1、 Part name :180809 Spule V2 #2

13、 Type of Mold : **Production Mould**

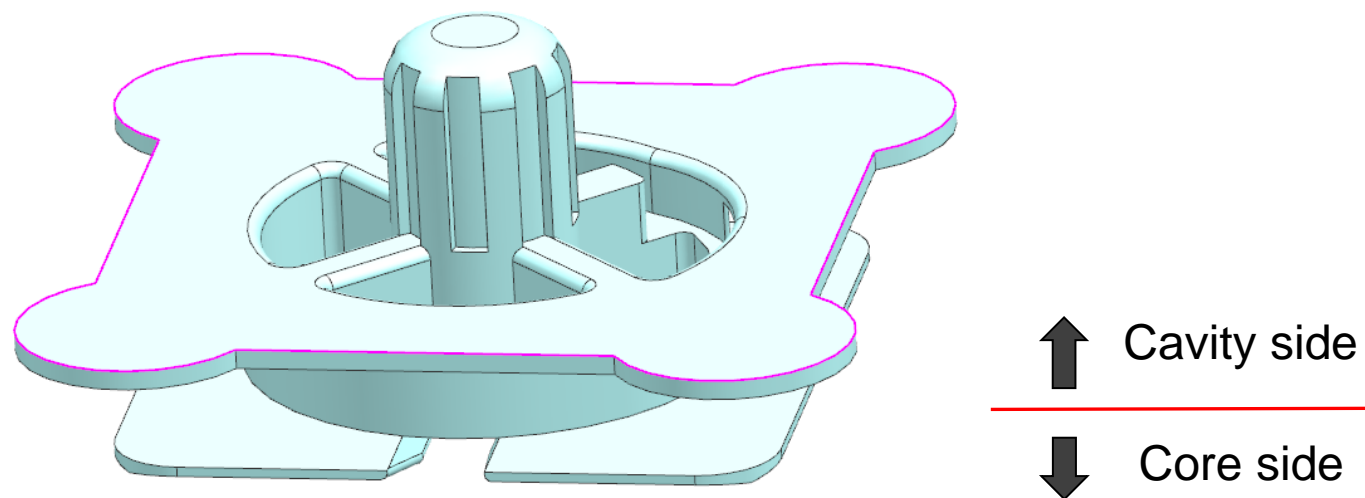
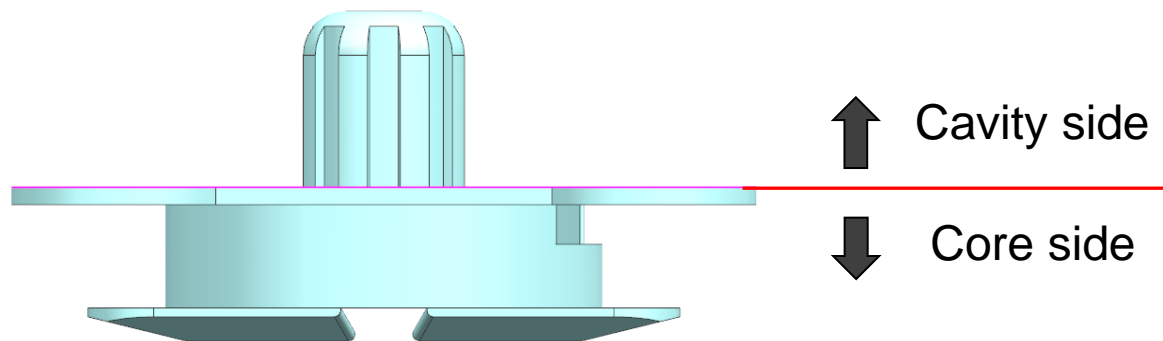
What is surface requirement for this side? VDI texture or ?

Slider parting line

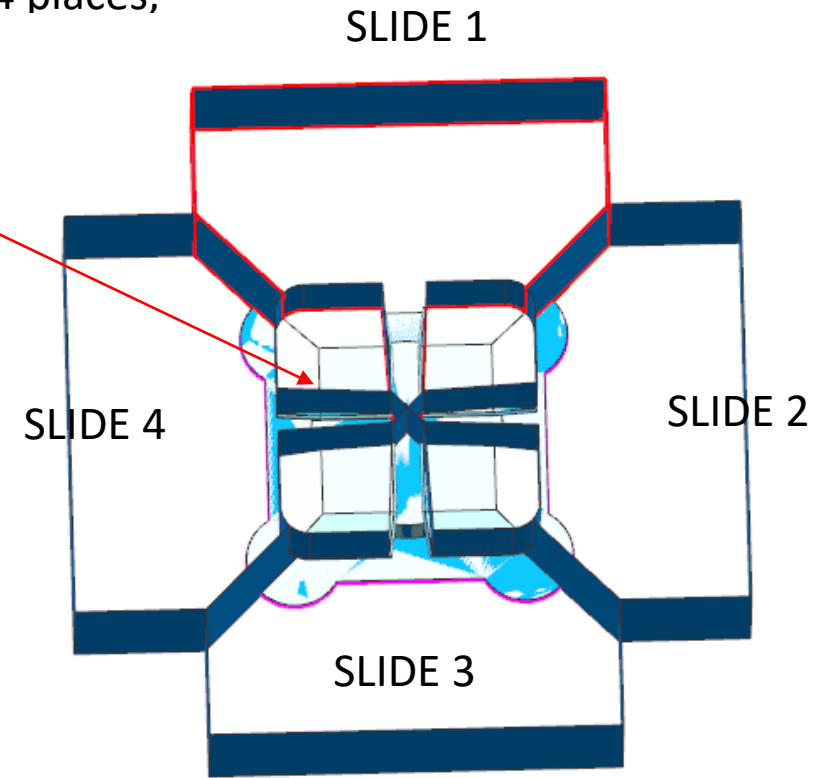
Slider parting line will be like this, total 4 places,
please check and confirm?

行位分型如图，共4个

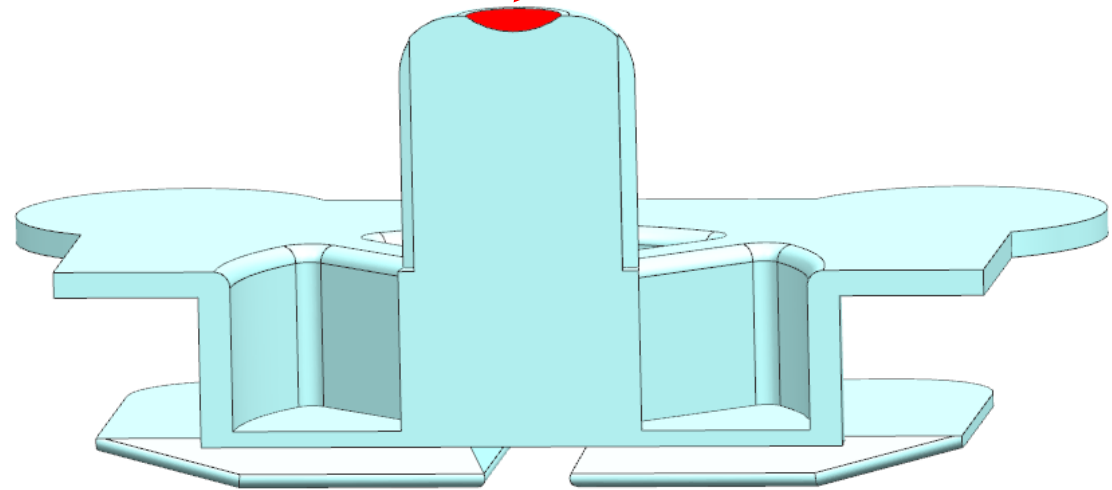
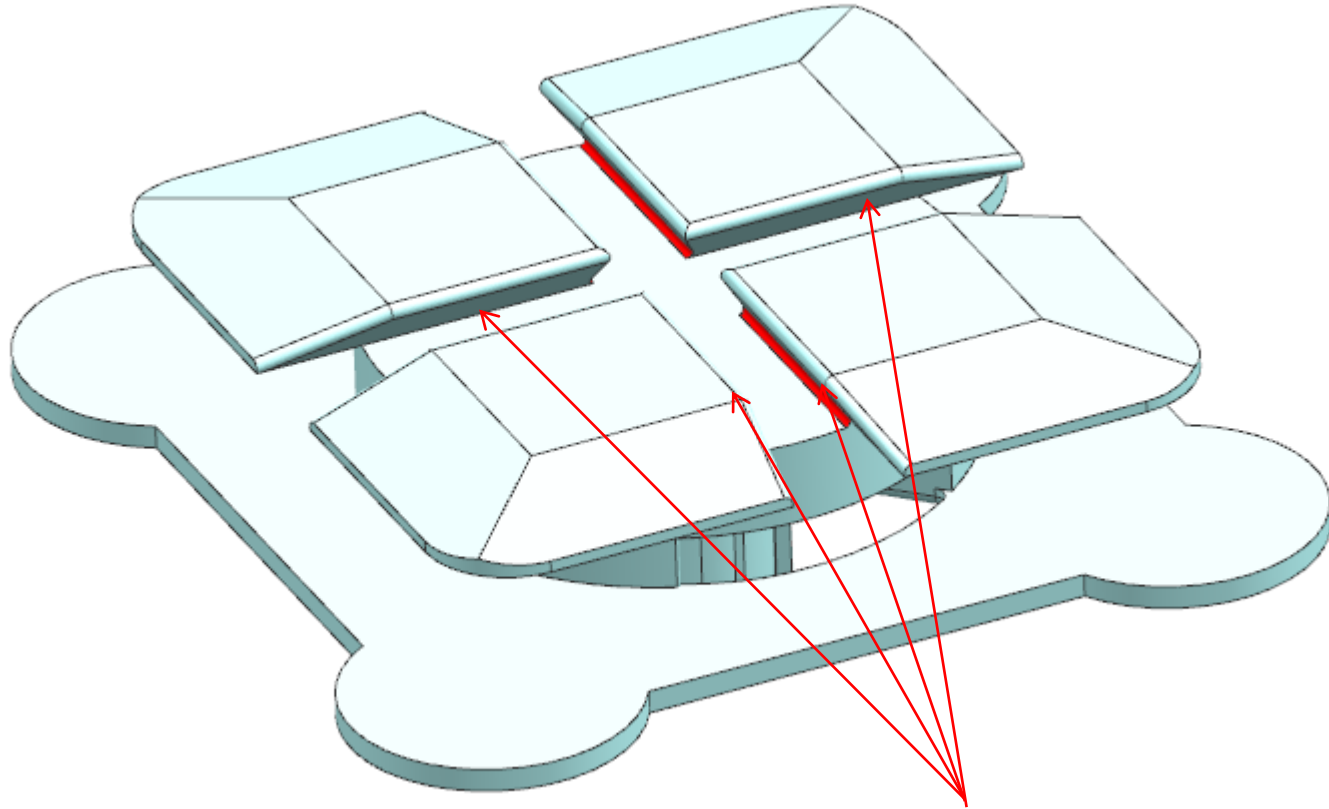
To avoid the gate vestigial here, we suggest to reduce some plastic and make dimple here, size will be 3 x 0.5mm(deep), please confirm?

YUDO hot runner two drops, one drop to one part,
This is gate point

Structure analysis

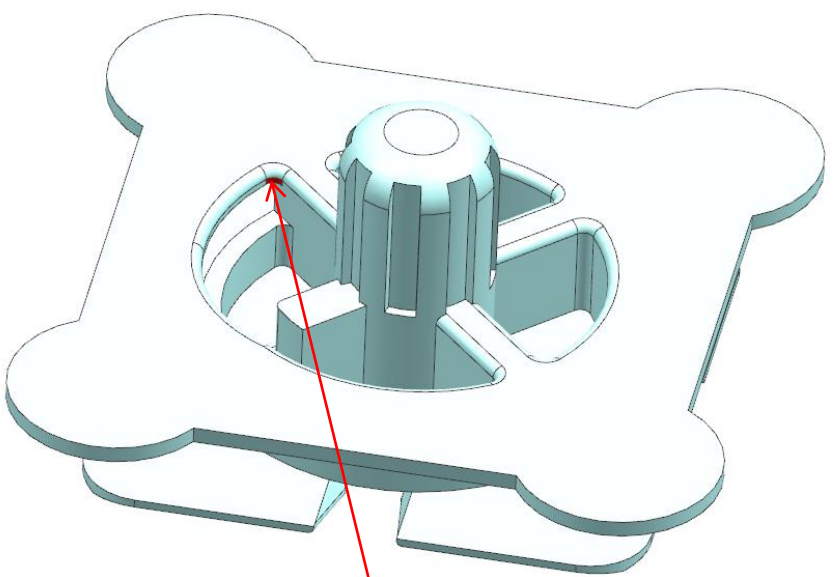
Some of area that has radius and some area does not have any radius, please check the part design and confirm ?

Structure analysis

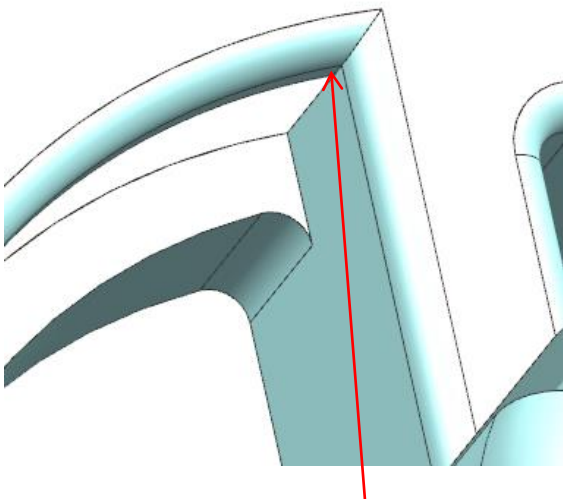
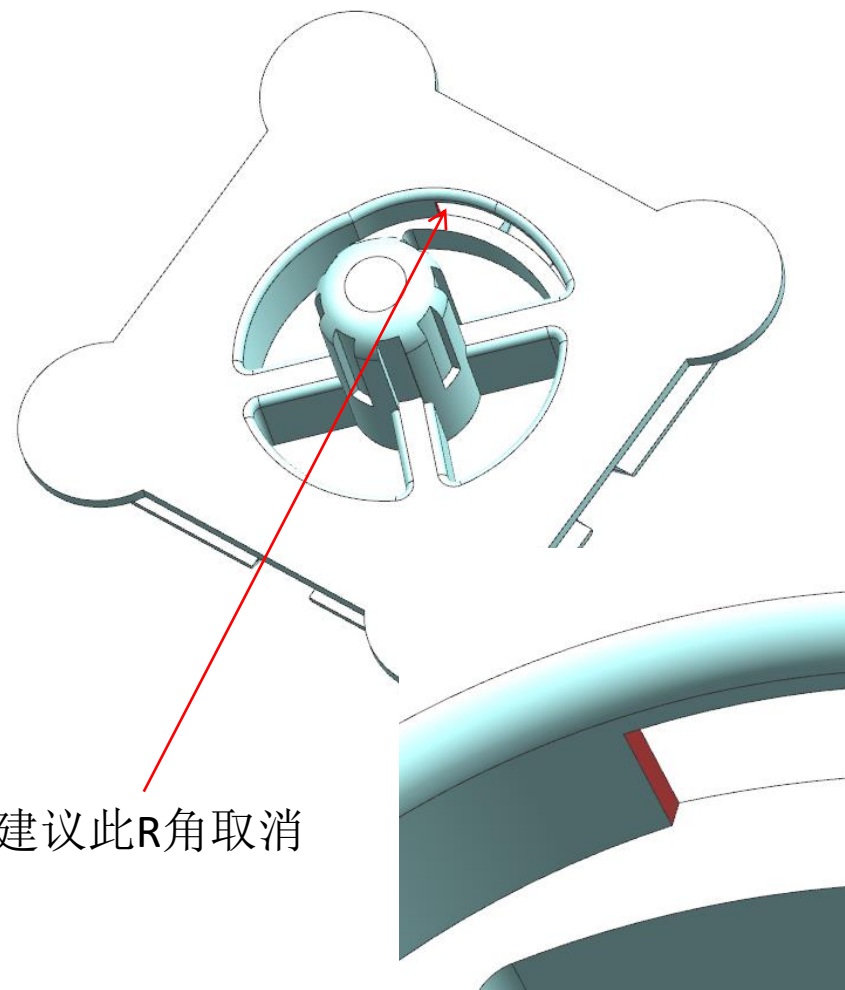
Suggest to check that area to

建议此R角取消

After change

更改后

Draft angle analyze

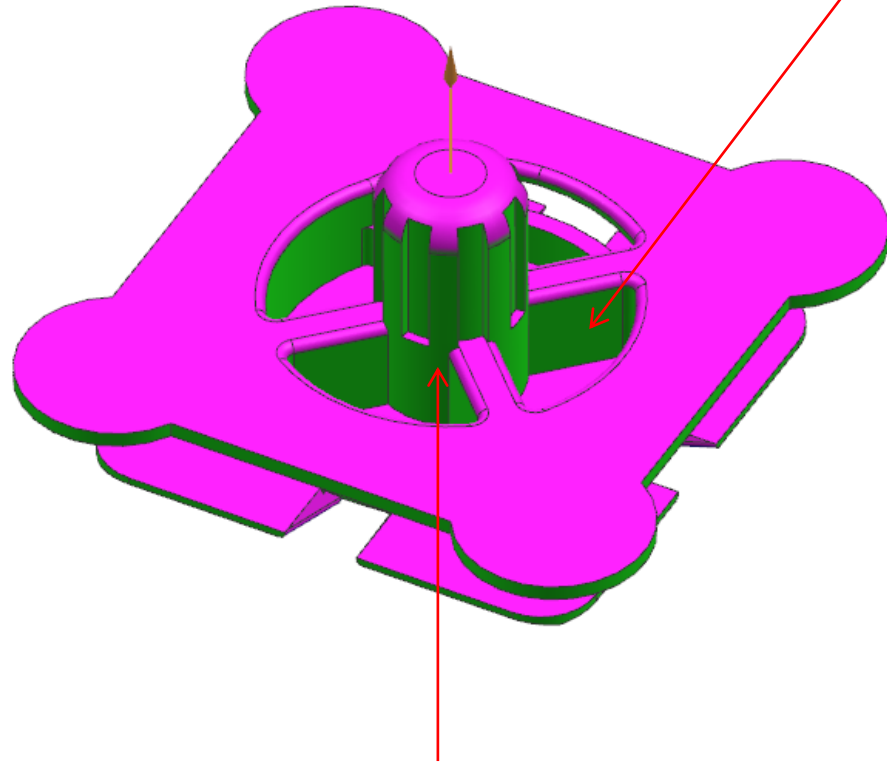
The green area does not have any draft angle,
we suggest to add 1.5 draft angle, to all of similar ribs

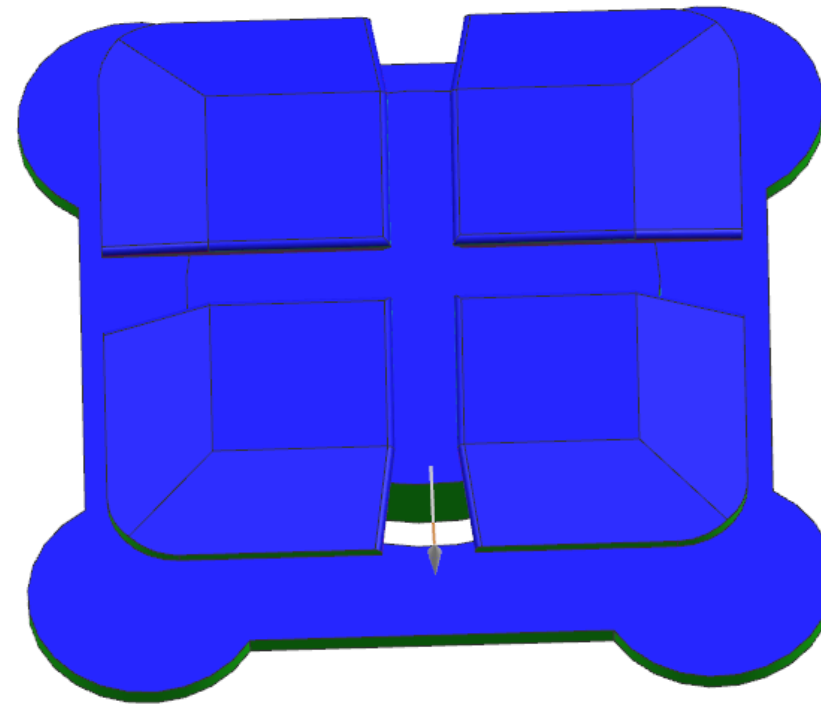
This boss does not have any draft angle on the green surface,
we suggest to add 1 degree draft angle by reducing plastics, please confirm?

Draft angle analyze

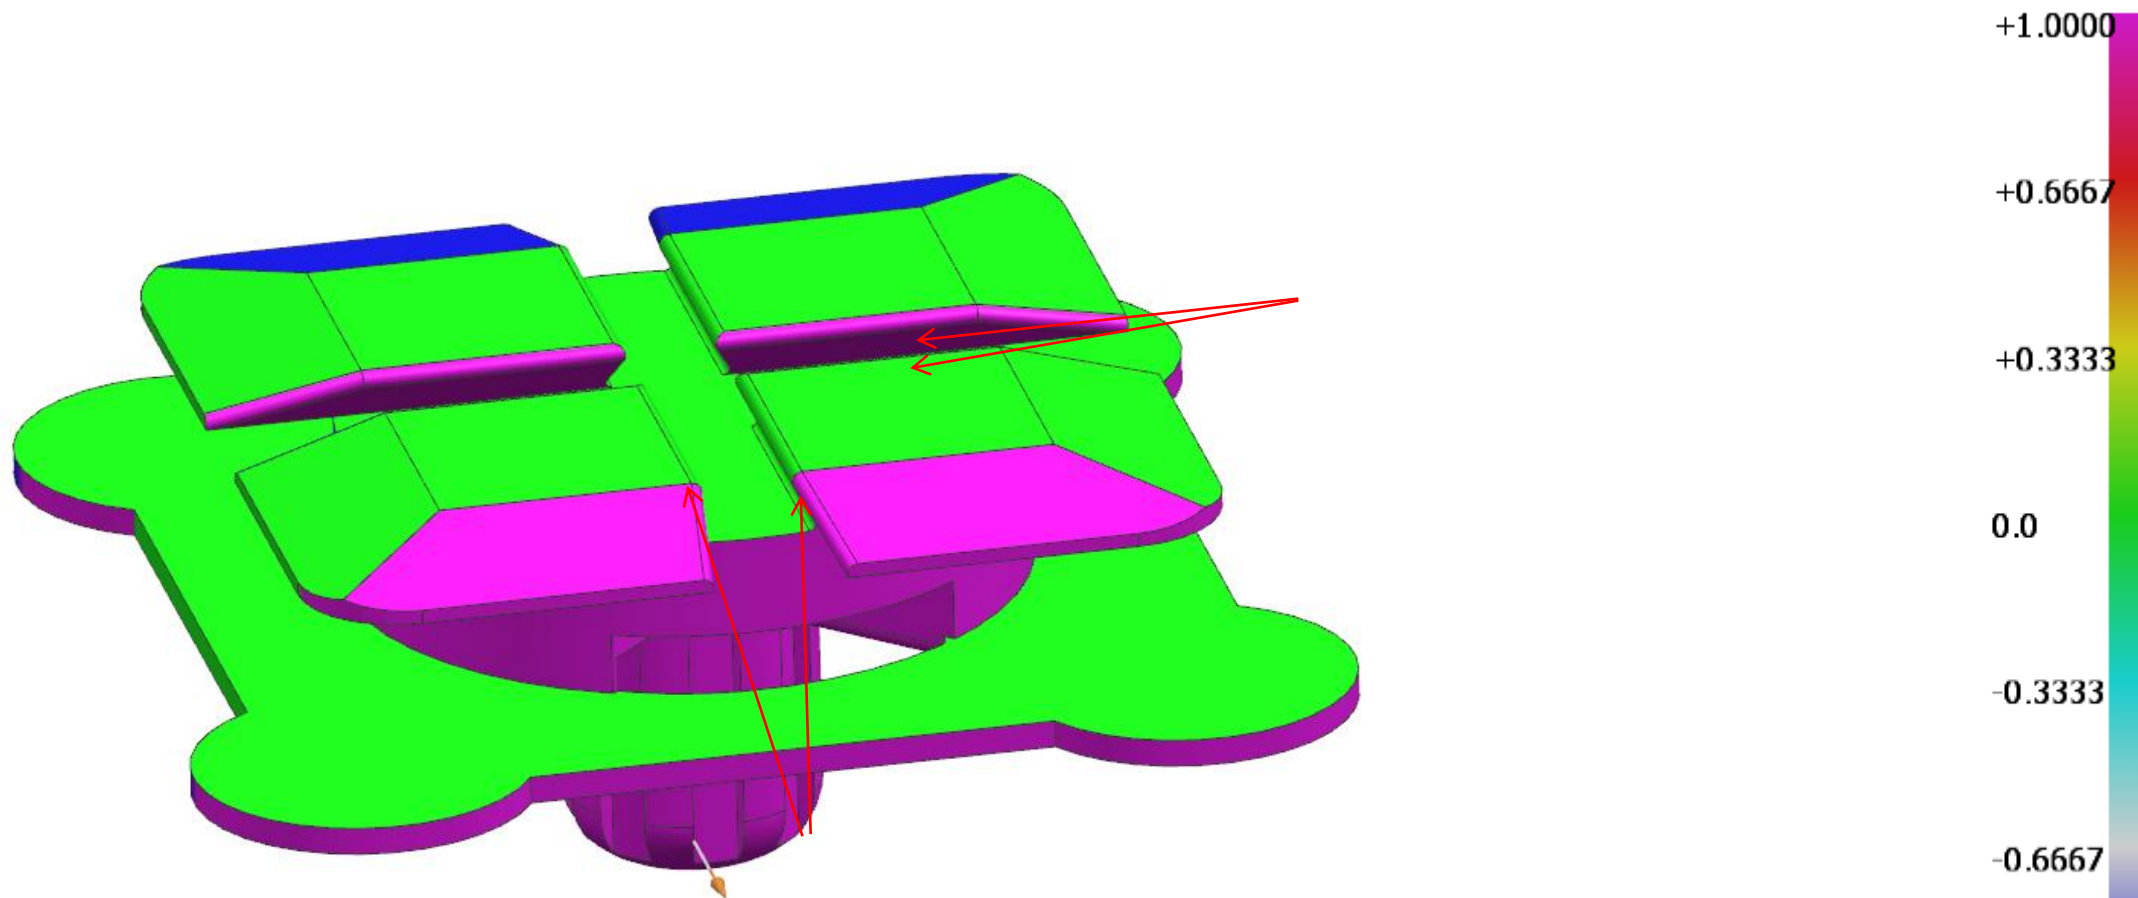
行位出模方向没有出模角，建议做
减胶拔模0.5度，请确认！共8处。

Ejector advise

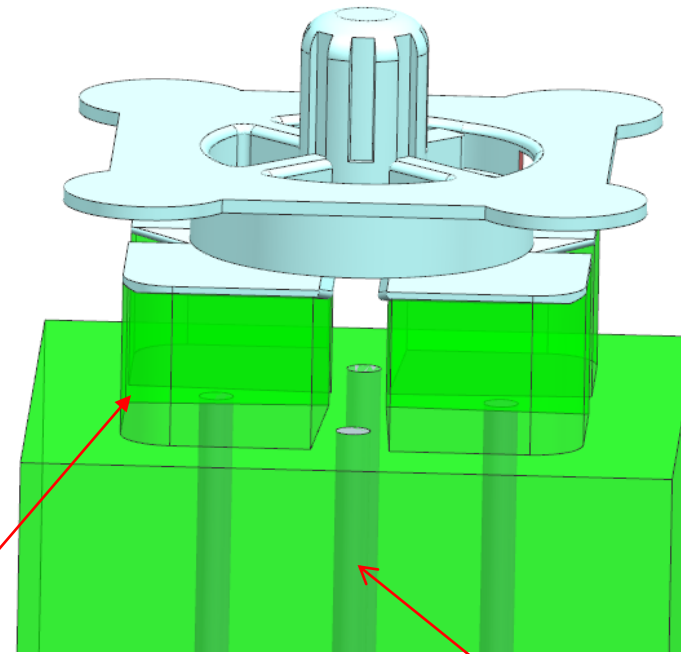
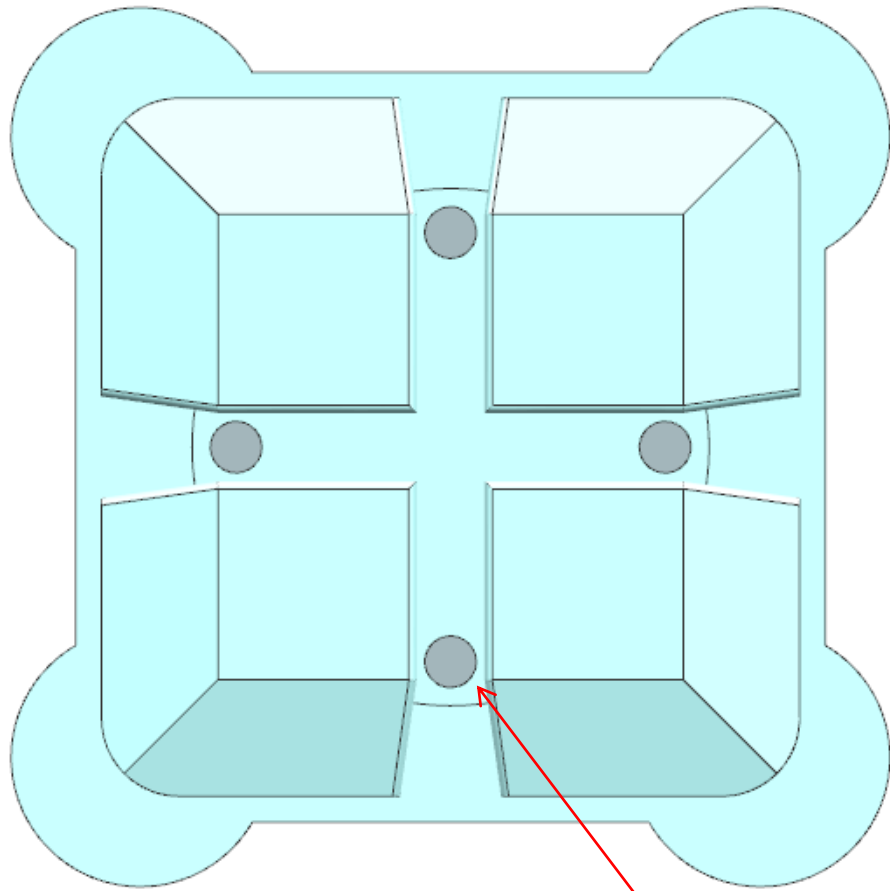
Ejector pins will be under the sliders, we will make earlier return systems to avoid ejection issue

Ejector pins diameter 2MM, this could avoid the ejector marks on the 4 plan surface,

total 4 pcs, please check if this is ok?

Thickness analyze

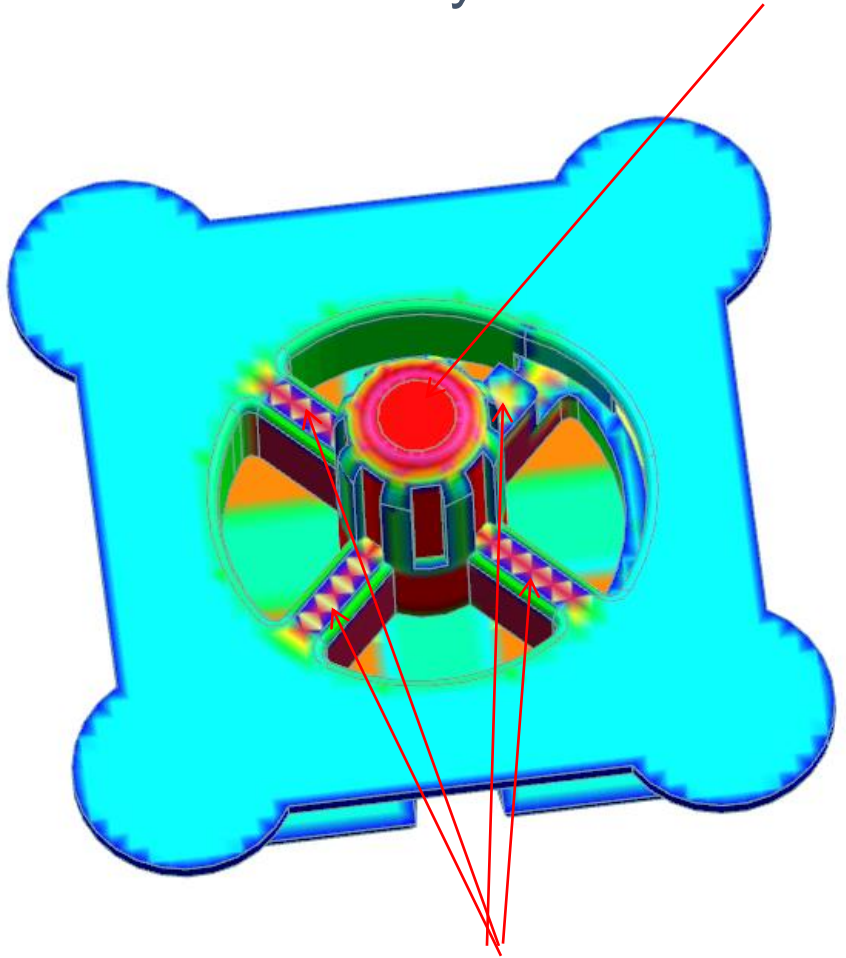
This boss will have sink mark due to unbalance wall thickness

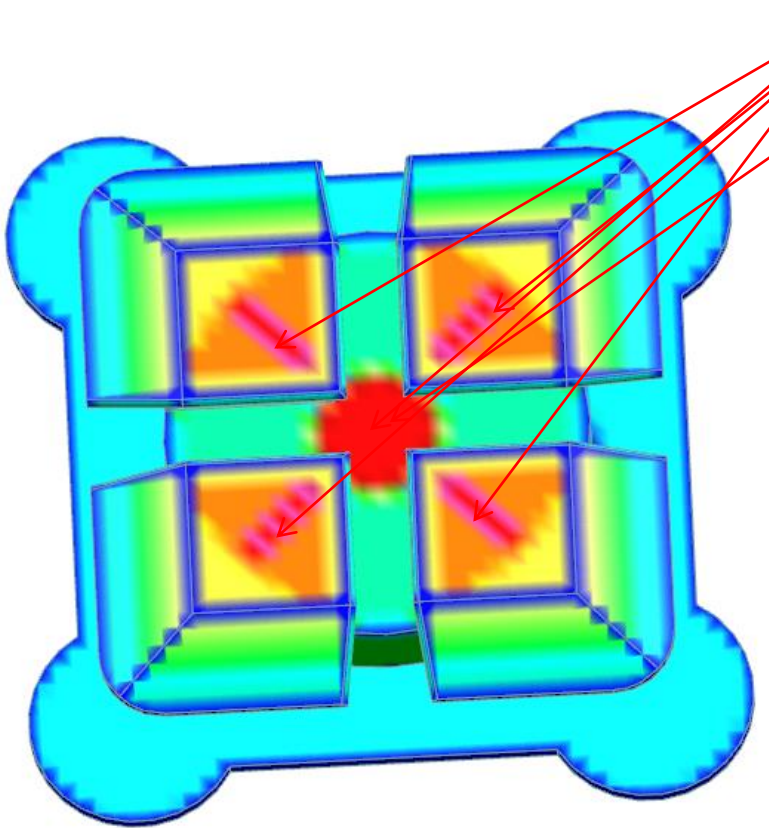
Those ribs are too thicker, may have some sink marks issue
